DSP-13048

Application	General Data	
Project Name: Potomac Business Park, Super Walmart Location: Southeast corner of the intersection of Oxon Hill Road (MD 414) and Clipper Way. Applicant/Address: Oxon Hill Associates, LLC 12500 Fair Lakes Circle, Suite 400 Fairfax, VA 22033	Planning Board Hearing Date:	05/15/14
	Staff Report Date:	04/24/14
	Date Accepted:	03/04/14
	Planning Board Action Limit:	Waived
	Plan Acreage:	15.44
	Zone:	I-3
	Dwelling Units:	N/A
	Gross Floor Area:	100,310 sq. ft.
	Planning Area:	76B
	Tier:	Developed
	Council District:	08
	Election District:	12
	Municipality:	N/A
200-Scale Base Map:	209SE01

STAFF REPORT

SUBJECT: Detailed Site Plan DSP-13048
Type 2 Tree Conservation Plan TCP2-122-95
Potomac Business Park, Super Walmart

BUILDING ELEVATIONS

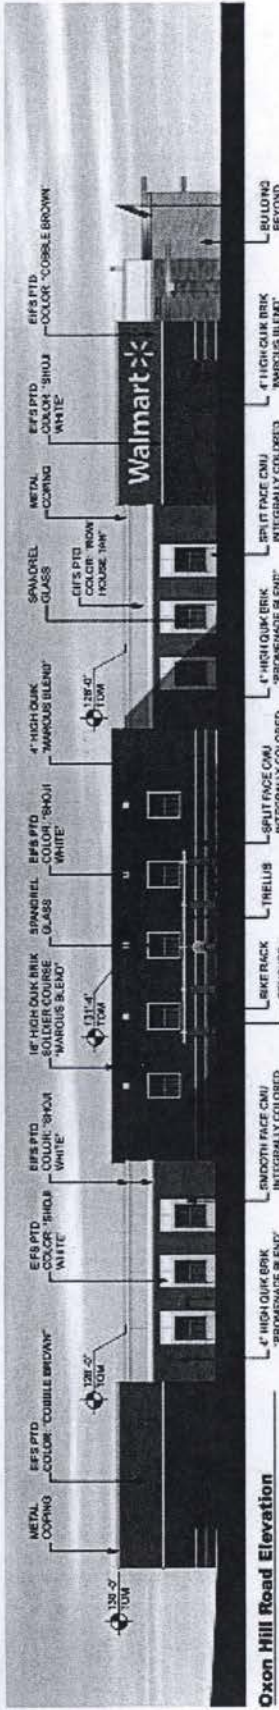
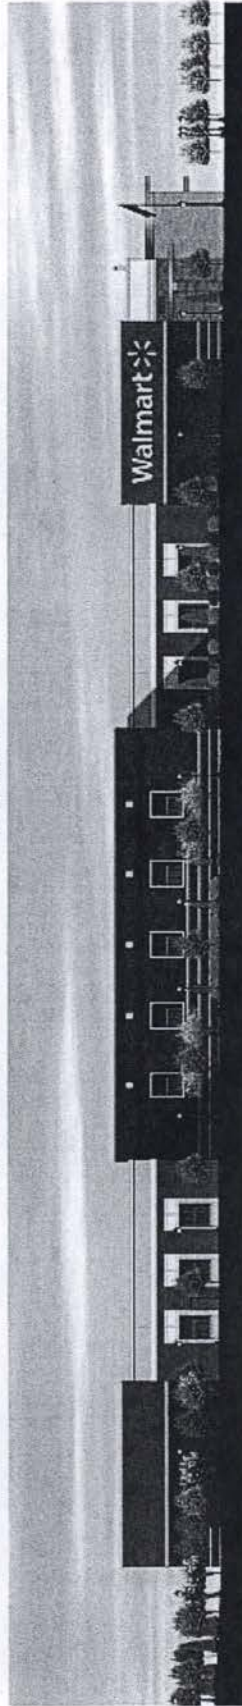
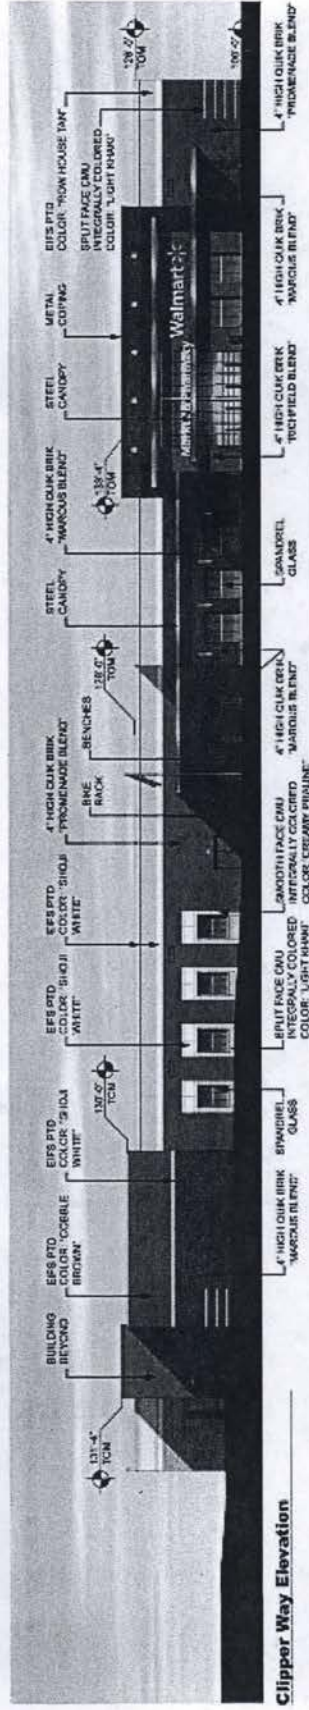
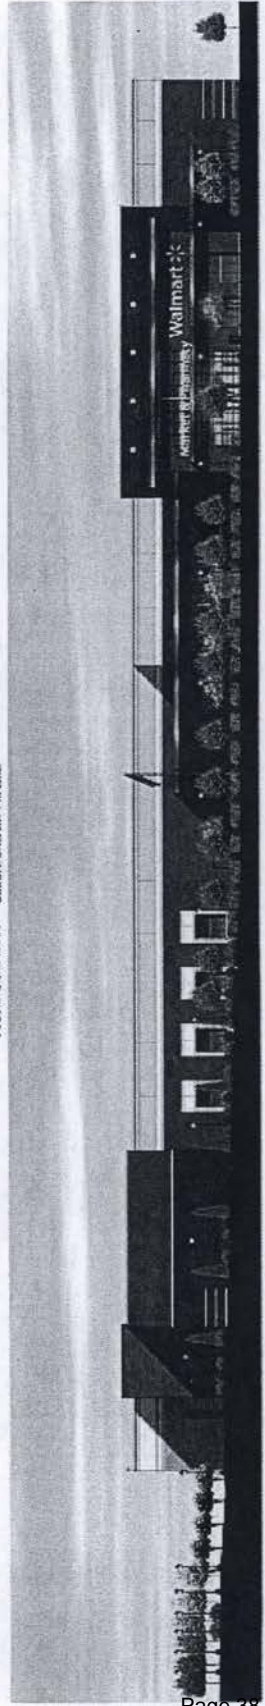
The proposed architecture on the northern and western façades utilizes a multiplicity of materials and design components that fail to present an aesthetically-pleasing unified whole. The façades along the northern, western, and southern sides of the building should be revised to arrange the materials, design elements, and massing in an architectural composition in which the parts relate better to one another and the architectural materials are cohesively organized, which is not the case with the current building design. Visual interest should be created by attention to the form and massing of the building, the use of quality and contrasting materials and colors, and the regular application of architectural detail. This same discussion was included in the SE-4738 technical staff report, with a recommended condition to revise the proposed architecture as described. For clarification purposes, more specific conditions have been included in the Recommendation section of this report regarding improvements that should be made to the architectural design prior to certification of the DSP.

PROPOSED BUILDING SIGNAGE

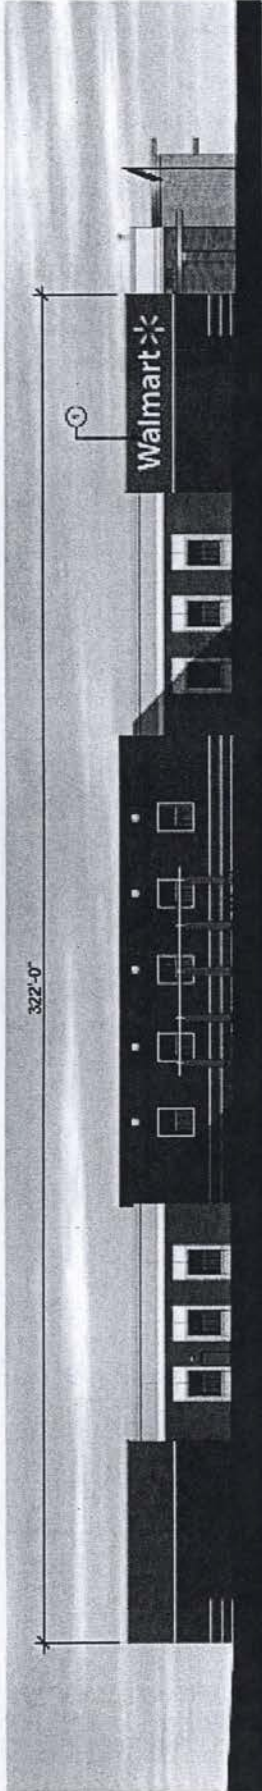
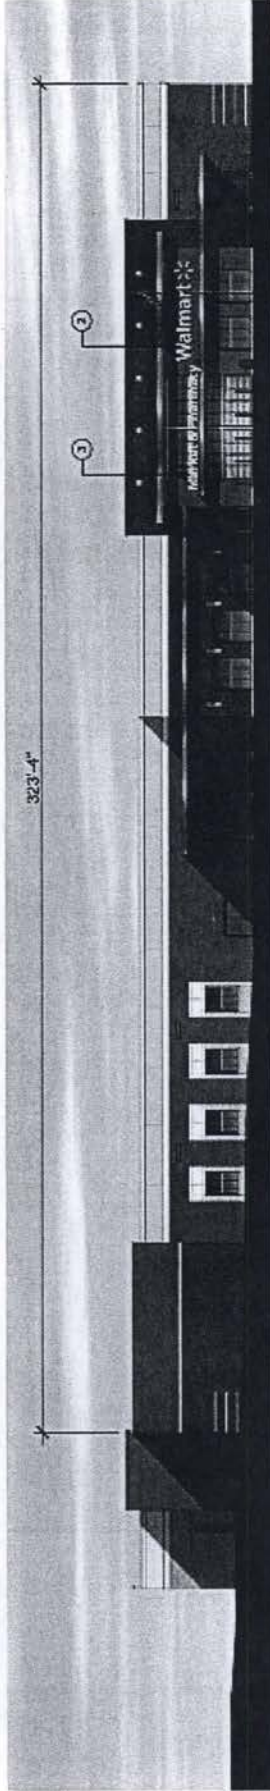
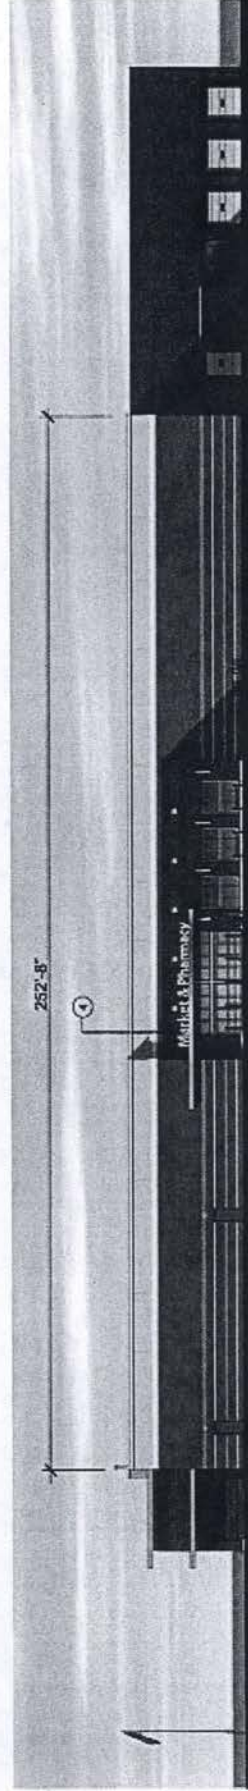
The lineal length of the building wall where the signs will be located is 327'-0". This allows for a sign area of 322 SF. Per SECTION 27-591(a), Figure 66 Part 1, and calculations in Table 1 - signage area C= 298 SF is to be reduced by 50%. The proposed calculated Area of Letters is 149 SF, which is less than the allowable sign area of 322 SF.

The lineal length of the building wall where the signs will be located is 323'-4". This allows for a sign area of 323.33 SF. Per SECTION 27-591(a), Figure 66 Part 1, and calculations in Table 2 - signage area C= 223.50 SF is to be reduced by 50%. The proposed calculated Area of Letters is 111.75 SF, which is less than the allowable sign area of 323.33 SF.

The lineal length of the building wall where the signs will be located is 252'-8". This allows for a sign area of 252.66 SF. Per SECTION 27-591(a), Figure 66 Part 1, and calculations in Table 3 - signage area C= 102.74 SF is to be reduced by 50%. The proposed calculated Area of Letters is 51.37 SF, which is less than the allowable sign area of 252.66 SF.
